# H5 Network PTZ Dome Camera Firmware

## Version: V5.5.27 Release Note

(2020-03-11)

## 3. Version Main Updates(Compared with V5.5.24)

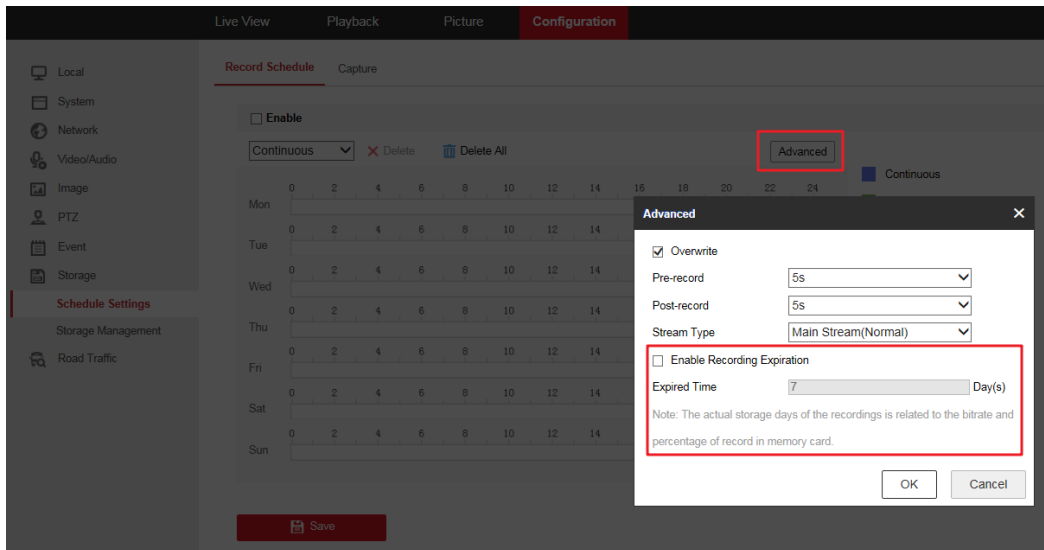
- **Newly support Road Traffic function. Support 100 countries in web browser and display United Kingdom by default:**

**1. Only the Vehicle Detection type is supported. The vehicle detection does not distinguish between the Entrance/Exit mode and City Street mode, and takes effect directly according to the City Street mode.**

**2. Does not support motorcycle identification.**

**3. Does not support vehicle feature recognition.**

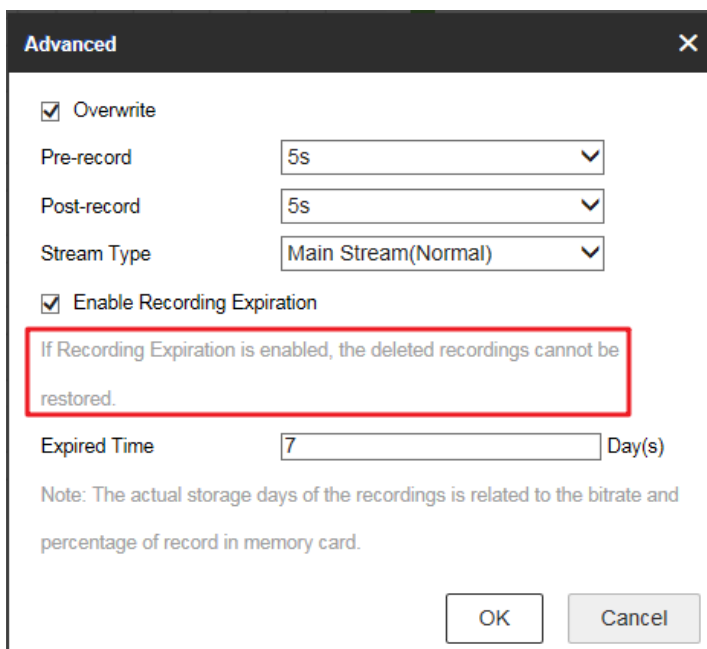
- **Newly support Recording Expiration in Recording Schedule. Records that exceed the Expired Time need to be deleted, and deleted videos cannot be recovered.**

**1. The Recording Expiration is disabled by default.**

**2. The expired time is in days, ranges from the 1 to 90 and the default is 7 days.**

**3. After enable this function, a prompt message will pop up: If Recording Expiration is enabled, the deleted recordings cannot be restored.**
